**BC BUILDING CODE INTERPRETATION COMMITTEE
AIBC, APEGBC, BOABC, POABC**

File No: 98-0160

INTERPRETATION

Subject: DWV piping for townhouses over parking slab

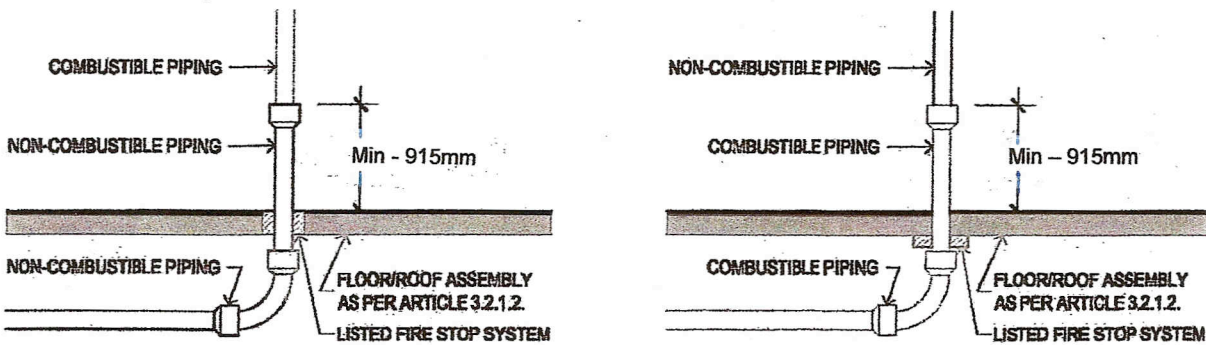
A project that consists of combustible townhouses that do not contain horizontal fire separation(s) constructed on top of a storage garage with concrete floor/roof assembly constructed according to Article 3.2.1.2.

Is it acceptable to change the drain, waste and vent (DWV) piping material from non-combustible to combustible and vice versa?

Yes.

Piping within a storage garage constructed in accordance with Article 3.2.1.2. must be the same type of material, non-combustible or combustible, including the portion penetrating through the floor/roof assembly and must have a listed fire stop system with the FT rating.

Note that the same pipe material must penetrate 900 mm above the floor/roof assembly in accordance with CAN4-S115-M testing criteria before it is allowed to change from combustible to non-combustible and vice versa.
